SUPPORT NOTE

SN-101

Tightening Sun EC1.3W Handles

#4 Nuts (25 plcs)

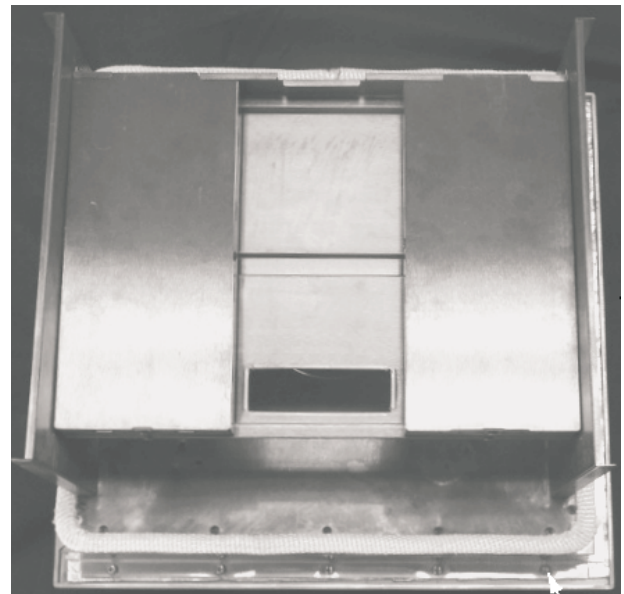
1. All of the #4 nuts and lock washers around the outside edge need to be removed so that the inside of the door can be lifted away from the front. In addition, the fiberglass rope needs to be removed from the purge hole so that friction on the high temperature cable does not hinder lifting. Note: There is no need to remove the load boxes or the brackets (internal or external) in order to tighten the handles.

3. One beveled screw should be replaced at a time with a #8-32 x 5/8" screw, #8 split lock washer, and #10 flat washer. Otherwise, alignment is easily lost and the repair is much more difficult.
